<b>JRPP No:</b>	2011SYE003
<b>DA No:</b>	DA524/10
<b>PROPOSED DEVELOPMENT</b>	Demolition of existing buildings and erection of new 8 storey mixed use development with basement car parking (amended plans)
<b>PROPERTY</b>	83-89 Chandos Street, St Leonards
<b>APPLICANT:</b>	Architects + Partners
<b>REPORT BY:</b>	Ian Pickles, Executive Planner, North Sydney Council
<b>DATE OF REPORT</b>	18 May 2011

## **Assessment of Amended Plans submitted in response to Panel's Decision.**

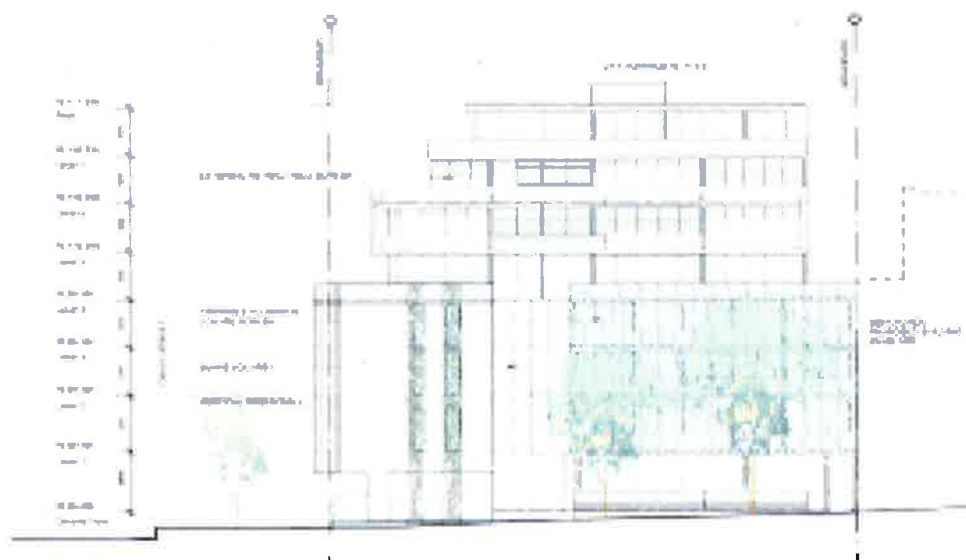
- b) Alter the design of levels 1, 2 and 3 to relocate the 2m wide balconies 2m back from the Chandos Street alignment, and redesign the apartments in the north-western part of levels 1, 2 and 3, in order that all living rooms have a minimum width of 4m and to accommodate the recessed balconies. This may involve a reduction in the number and/or size of these dwellings.**

The amended plans achieve these requirements, involving the reconfiguration of the 1 x studio unit and 2 x 2 bedroom units on the north-west part of the building on levels 1, 2 and 3 with 1 x studio unit, 1 x 1 bedroom unit and 1 x 2 bedroom unit, to accommodate the recessed balconies to the northern elevation. The size and lay-out of these units in the amended plans are satisfactory, with each unit having a 4m wide living room and a 4m x 2m balcony, and unit sizes being in excess of the SEPP 65 'rule of thumb' minimum.
